Office Action Summary

10/715,703

DETAILED ACTION

Annotated Marked-Up Drawing

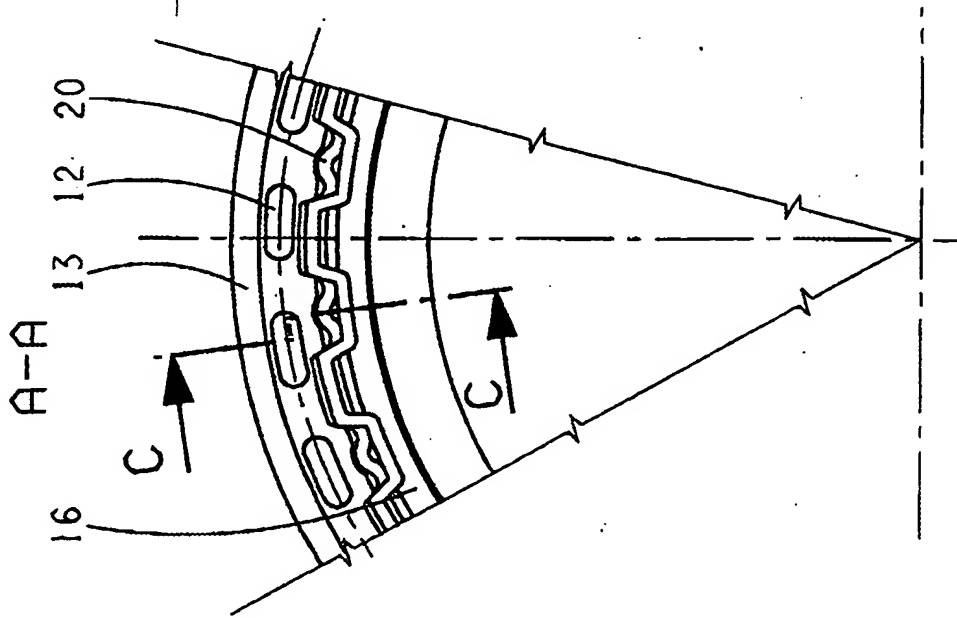
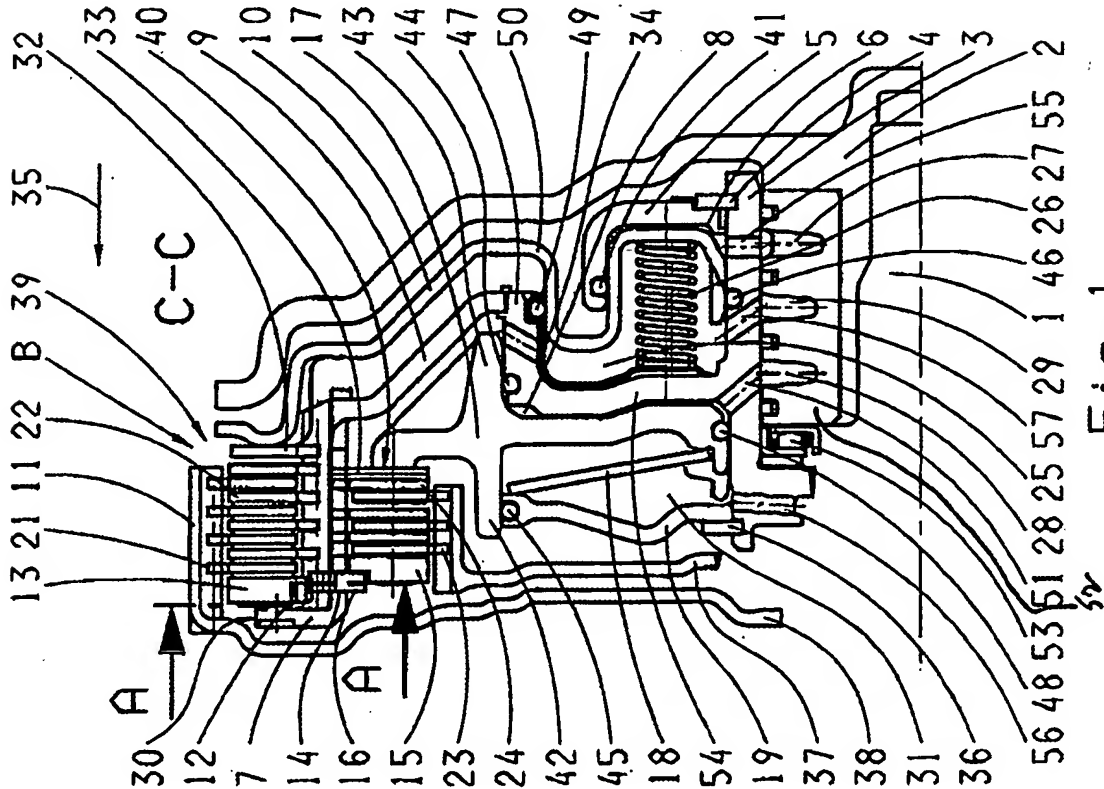
Receipt is acknowledged proposed drawing change filed May 5, 2005. The proposed change is approved. Corrected drawings should have been submitted in response to the previous Office action. The objection is repeated below:

The drawings are objected to as failing to comply with 37 CFR 1.84(p)(5) because they do not include the following reference sign(s) mentioned in the description: **52. Corrected drawing sheets in compliance with 37 CFR 1.121(d) are required in reply to the Office action to avoid abandonment of the application.** Any amended replacement drawing sheet should include all of the figures appearing on the immediate prior version of the sheet, even if only one figure is being amended. The replacement sheet(s) should be labeled "Replacement Sheet" in the page header (as per 37 CFR 1.84(c)) so as not to obstruct any portion of the drawing figures. If the changes are not accepted by the examiner, the applicant will be notified and informed of any required corrective action in the next Office action. The objection to the drawings will not be held in abeyance.

Approved
OSB
06/21/05
